# GEORGETOWN UNIVERSITY TOWNHOUSE EXTERIOR REPAIRS

OLD GEORGETOWN BOARD SUBMISSION - JANUARY 2023

Re: Response to Comments: Project Address: 1316 36 St. NW

ROOF PLAN AND DETAILS

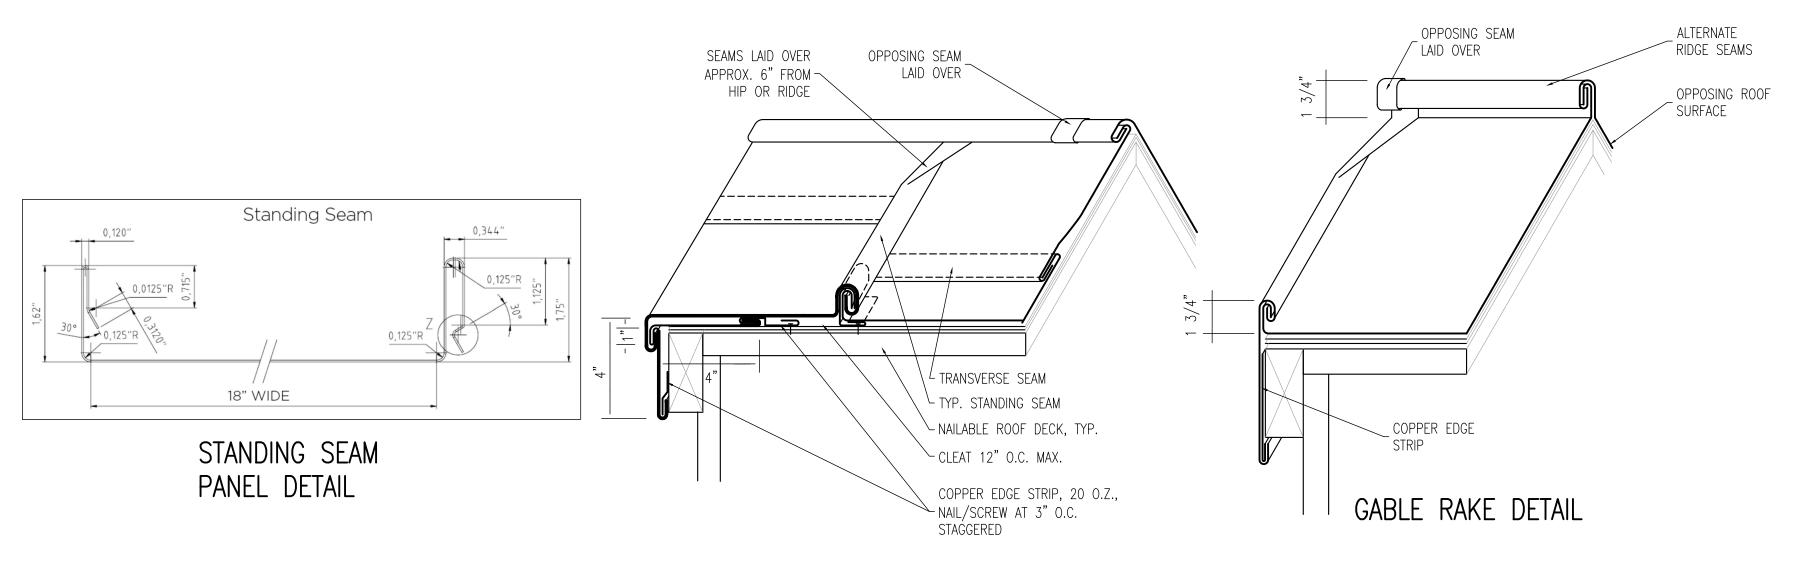
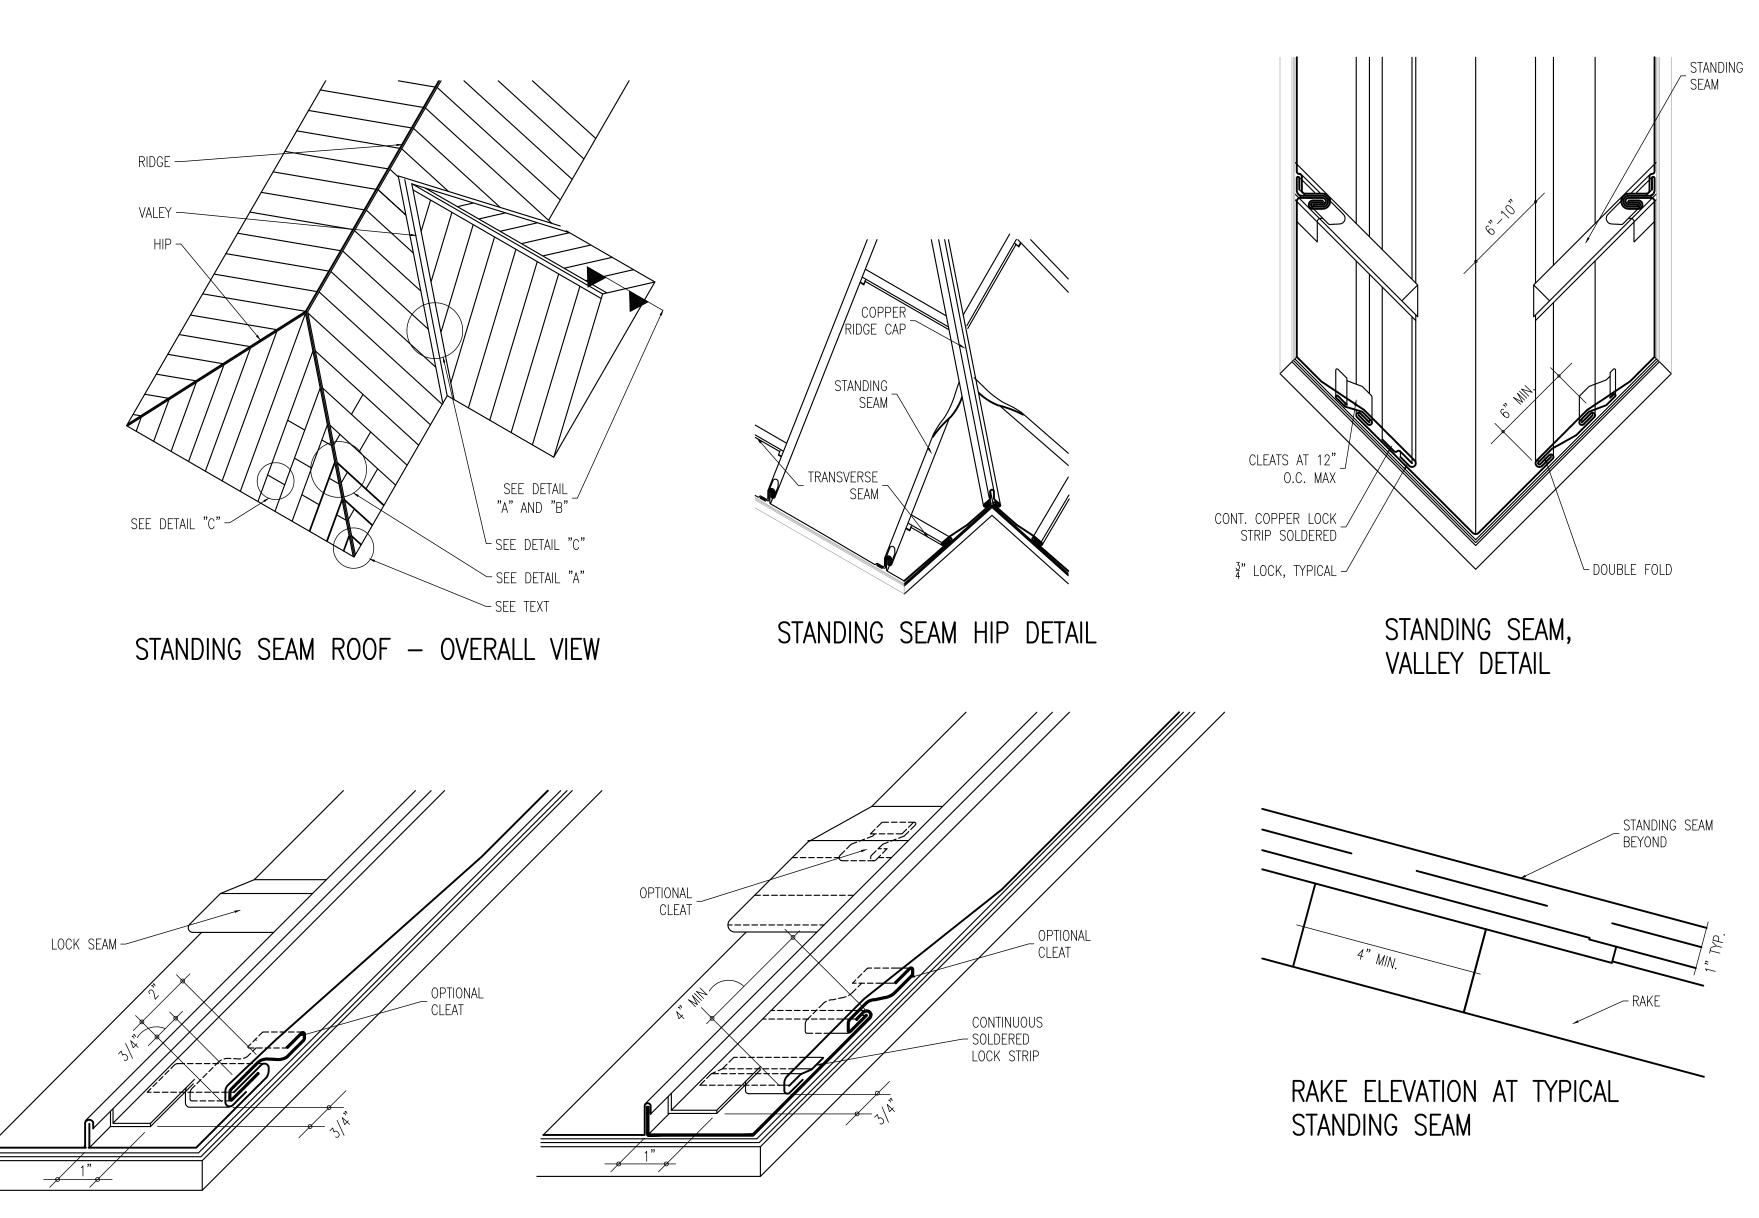
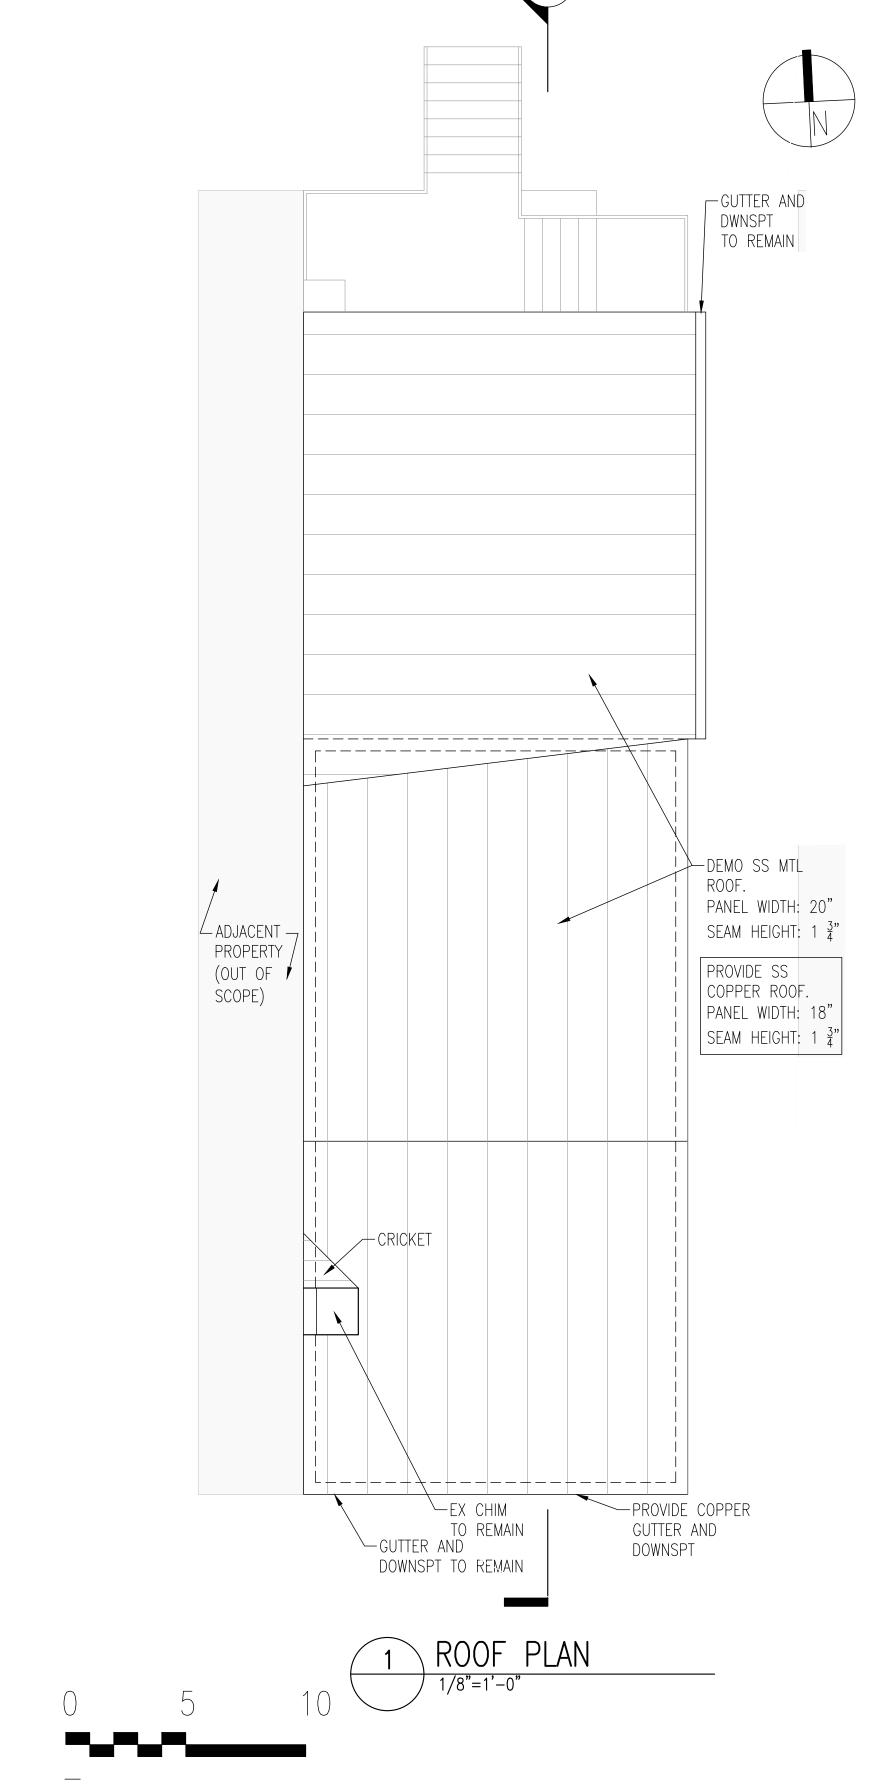
2. Please amend your application to include documentation of the existing metal roof panel widths and seam heights. The OGB typically likes replacement metal roofing to match the existing conditions.

> Information regarding the roof seam height and spacing has been added to the drawings. See A6

ROOF DETAILS

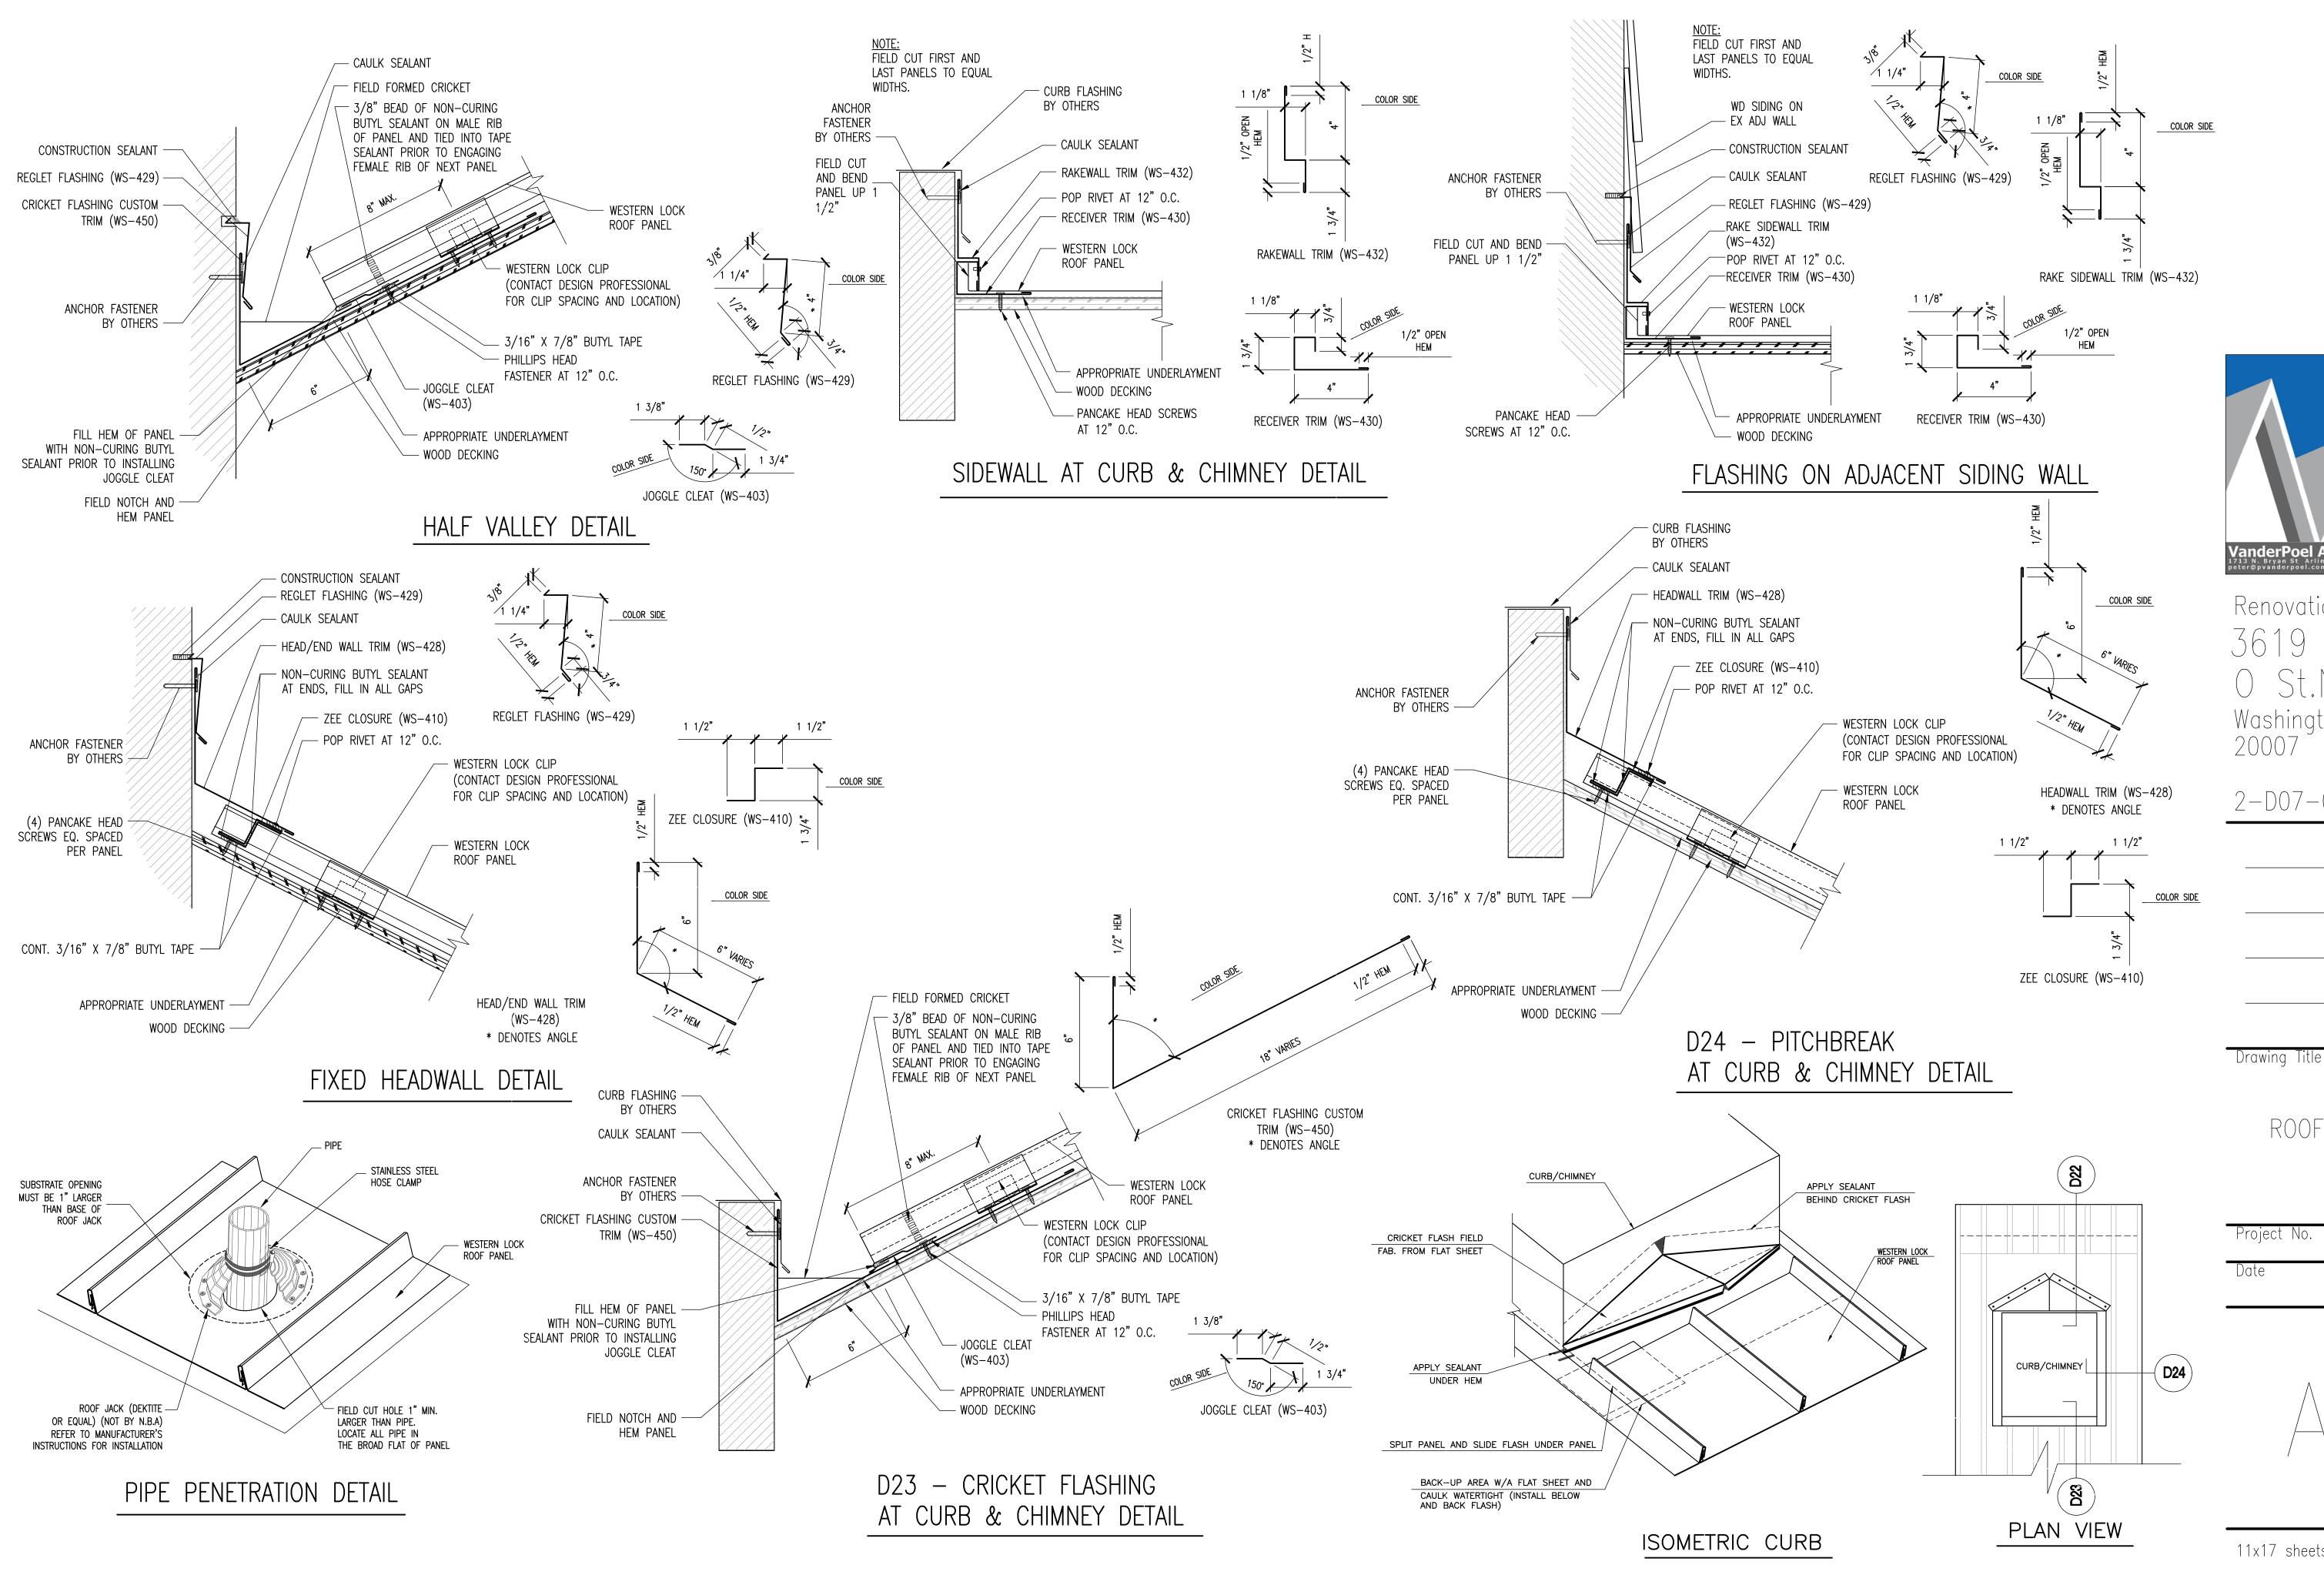
I am a bit confused as to how the roof will terminate at the neighbor's wall to the west. Can you clarify?

Would the roofing be regleted into the masonry chimneys? 4.

> We propose removing the existing flashing from the east face of the neighboring building, providing siding and trim to match the west face of the existing of the neighboring building and inserting new wall/roof flashing under the new siding. See images 28, 29 and drawing details, A7

> We propose raking the chimney mortar joints, inserting counter flashing with sealant where the counter flashing is inserted into the brickwork. See A7
